DESIGN REVIEW COMMISSION MEETING
UPPER LEVEL, CONFERENCE ROOM #6
710 E. MULLAN
THURSDAY, October 24, 2019
12:00 pm

DESIGN REVIEW COMMISSION STAFF REPORT

SUBJECT: **DR-4-19: REQUEST FOR AN EARLY DESIGN CONSULTATION WITH THE DESIGN REVIEW COMMISSION FOR A FOUR (4) STORY, 121 ROOM HOTEL WITH SURFACE PARKING IN THE C-17 (COMMERCIAL) ZONING DISTRICT**

LOCATION: **2119 N GOVERNMENT WAY**

Section of the 2017 Trails and Bikeways Master Plan for I-90/95 location:

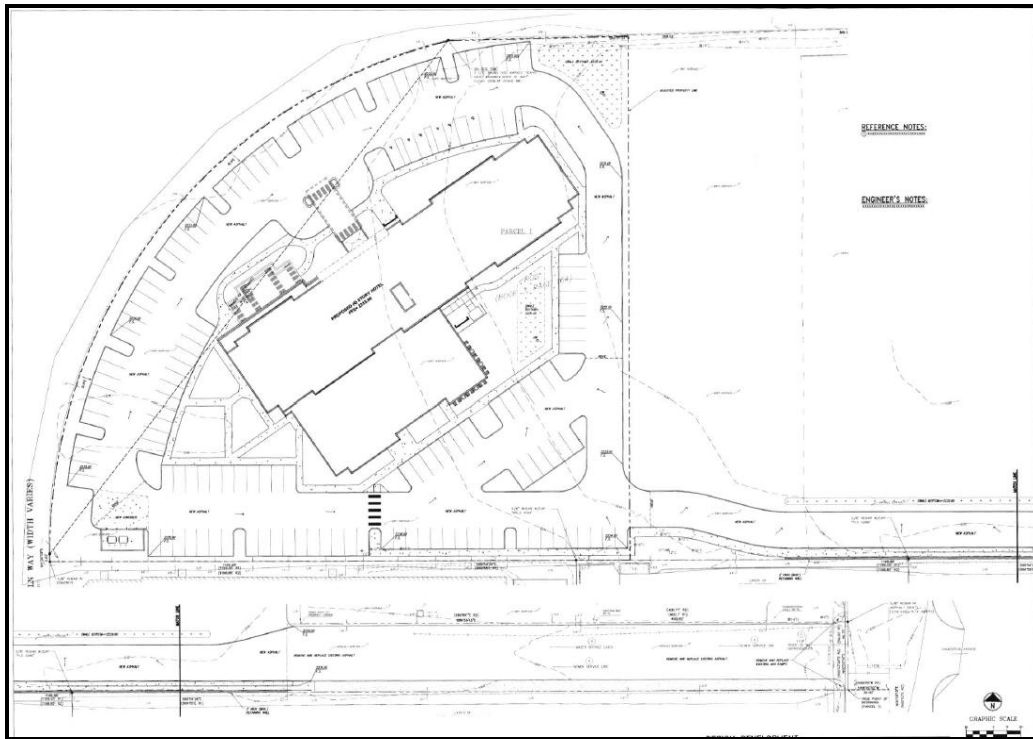
Site photos on pages 6-8 show the existing sidewalk along the Government Way access point extending westerly along a portion of the drive isle. The project is required to provide sidewalks and walkways in order to meet the Commercial Design Guidelines and City Code requirements. In addition, the Trails Coordinator has requested a multi-use pathway on the property and along the ITD I-90 and US95 right-of-way consistent with the adopted Trail and Bikeway Master Plan as shown in the image below.

Chapter 3, section A of the 2017 Trails and Bikeways Master Plan requires this trail be built as an extension of the 95 trail. (See below)

Staff's recommendation (Sidewalks Deviation Request): At a minimum, a sidewalk and multi-use pathway will be required to meet code requirements and adopted design guidelines and master plans. However, there is some ability to work with the applicant on the exact location and material to be used, and evaluate if existing sidewalks on the private drive off of Government Way need to be extended, and figure out where a trail connection to meet the intent of the adopted Trails and Bikeways Master Plan can be accommodated. Staff can work with the applicant before the second meeting to refine the location of sidewalks/pathway and provide further guidance on the design departure request.

SITE PLAN- PARKING/LANDSCAPING PLAN:

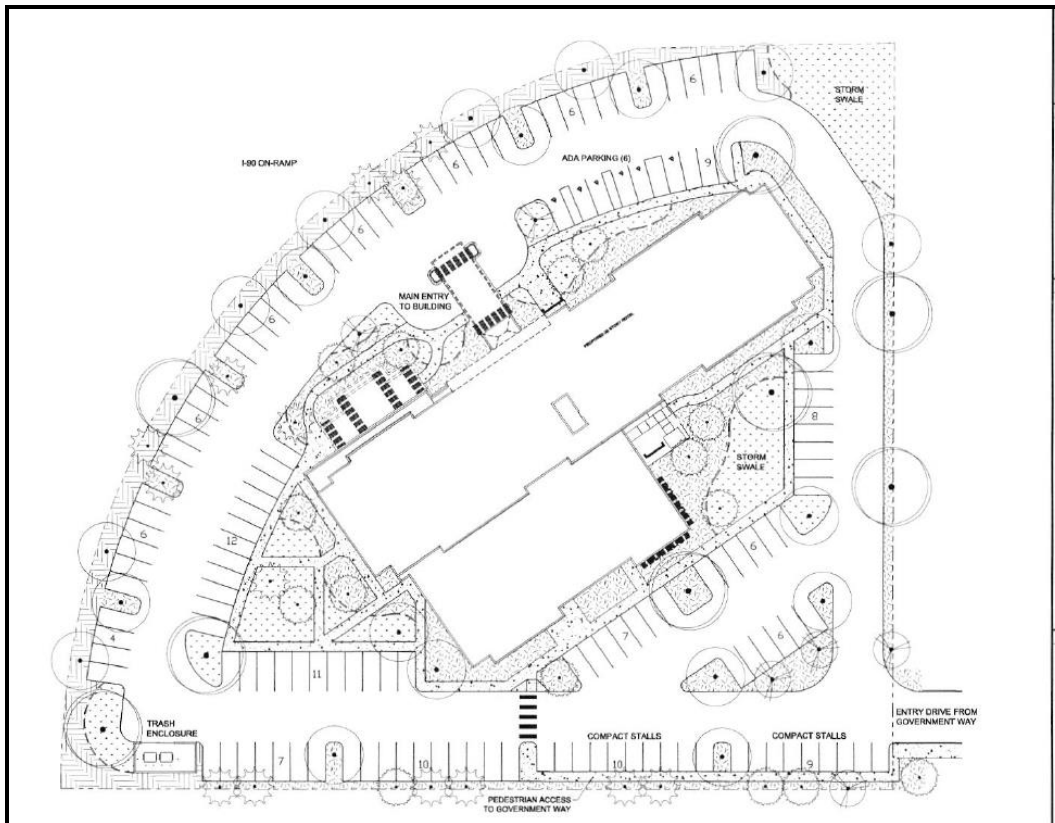
The applicant has requested a Design Departure for “Sidewalks Along Street Frontages” stating in the Narrative that introducing a public pathway down to the intersection of I-90 and Highway 95 without direct access to either would not meet the intent of the guideline as it would endanger the public.

The applicant has also requested a Design Departure for “Walkways” reiterating in the Narrative that introducing a public pathway down to the intersection of I-90 and Highway 95 without direct access to either would not meet the intent of the guideline as it would endanger the public.

Staff's recommendation (Walkways Deviation Request): Staff recommends denial of the walkway deviation. The applicant will need to provide the pedestrian walkway through the parking lot with the "ladder" striping to create the clear route of movement for the pedestrians from the hotel to the future pedestrian trail/sidewalk. This is standard practice with parking lot striping.
